Office Action Summary	Application No. 10/576,880	Applicant(s) EOM ET AL.	
	Examiner AZIM RAHIM	Art Unit 3744

DETAILED ACTION

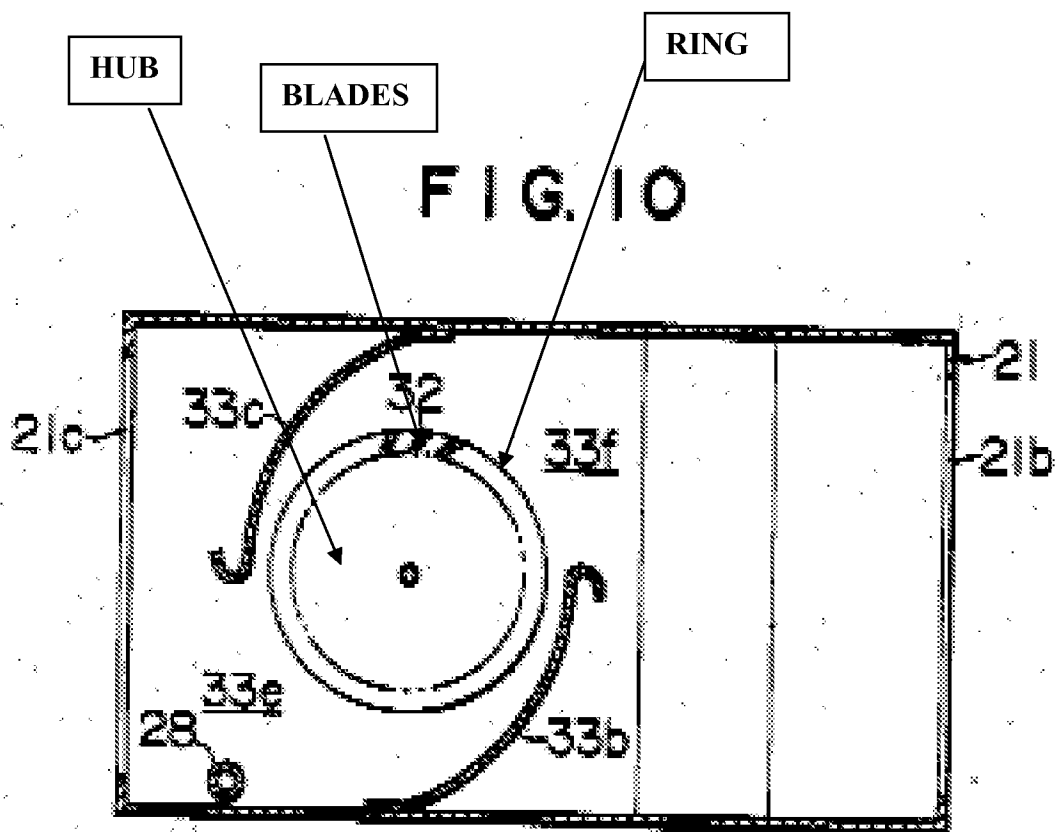
Regarding claim 1, Hosoda et al. teach an air conditioner (figs. 8-10) comprising: a case (21) of which one side is positioned at an indoor side (side adjacent to evaporator 31) and another side is positioned at an outdoor side (side adjacent to condenser 34); an indoor heat exchanger (evaporator 31) mounted inside the case (illustrated in figure 9) positioned at the indoor side (illustrated in figure 9) thus to be heat-exchanged with the indoor air (see arrow flowing through the evaporator); an indoor centrifugal fan (29) opposite to the indoor heat exchanger (illustrated in figure 9) for generating a blowing force so that the indoor air can pass through the indoor heat exchanger (the indoor heat exchanger is capable of performing this

intended use function); an outdoor heat exchanger (34) mounted inside the case (illustrated in figure 9) positioned at the outdoor side (illustrated in figure 9) thus to be heat-exchanged with the outdoor air (see arrow flowing through the condenser); and an outdoor centrifugal fan (32) opposite to the outdoor heat exchanger (illustrated in figure 9) that generates a centrifugal force to blow the outdoor air [this intended use limitation is capable of being performed by the outdoor centrifugal fan], wherein the outdoor centrifugal fan comprises: a hub (annotated below) formed in a disc shape (illustrated below) connected to a driving motor (35) by a rotational shaft (shaft extending between the motor and both blowers 29 and 32); a plurality of blades (annotated below) each having one end protruding from a surface of the hub (illustrated below) and disposed at the outer side of the hub in a circumferential direction (illustrated below) with the same interval therebetween (illustrated below); and a supporting ring (the ring as annotated below) coupled to another end of each of the plurality of blades to support the blades [as illustrated below, portions of the ring are disposed in a vicinity between the blades]. It is noted that the Applicant has not specified the boundaries of the indoor side and the outdoor side.

Regarding claim 2, Hosoda et al. teach the limitation of an outdoor air suction port (21a) being respectively formed at both lateral surfaces of the case (as illustrated in figure 8, since the outdoor suction port has a surface area, it is disposed at “lateral sides” of the case) positioned at the outdoor side (illustrated in figure 8), and an outdoor air discharge port (34) is formed at the rear surface of the case (illustrated in figure 8).

BLOWN UP VERSION OF FIGURE 9

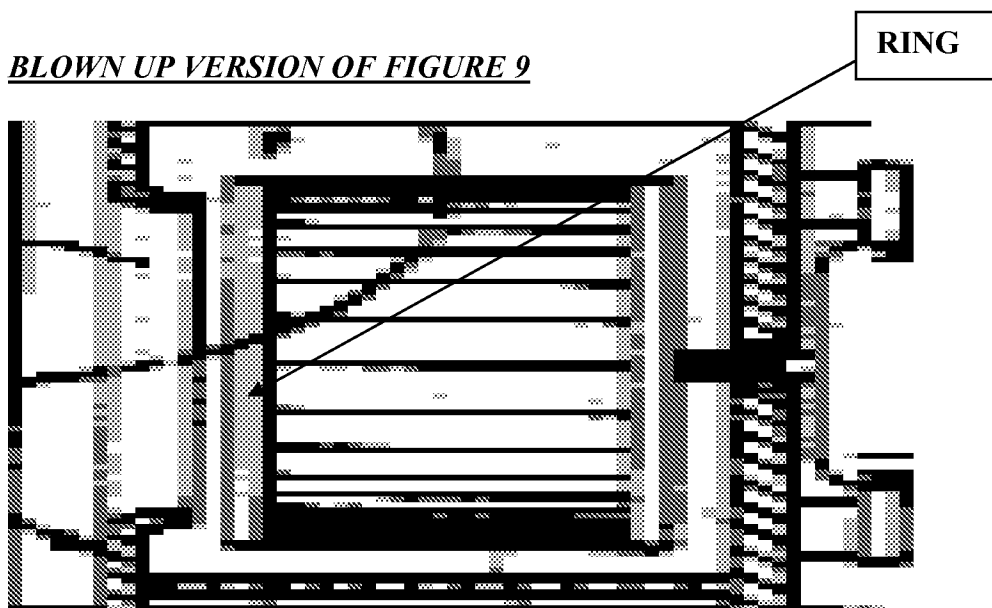
Regarding claim 3, Hosoda et al. teach the limitation of the outdoor fan being installed in a shroud (the combination of 24 and 25) mounted inside the case positioned at the indoor side (illustrated in figure 9), and the shroud is provided with an air guide (25) that guides air blown from the outdoor centrifugal fan to the outdoor heat exchanger [illustrated in figure 9].

Regarding claims 5 and 6, Hosoda et al. teach a condensing water dispersing ring (39) mounted at the outdoor centrifugal fan (illustrated in figure 9) for dispersing condensing water collected at the lower surface of the case to the outdoor heat exchanger (the dispersion unit is positioned to perform this intended use function), the condensing water dispersing ring being connected to the outdoor fan thus to be rotated together for dispersing the condensing water (see column 7, lines 7-10).
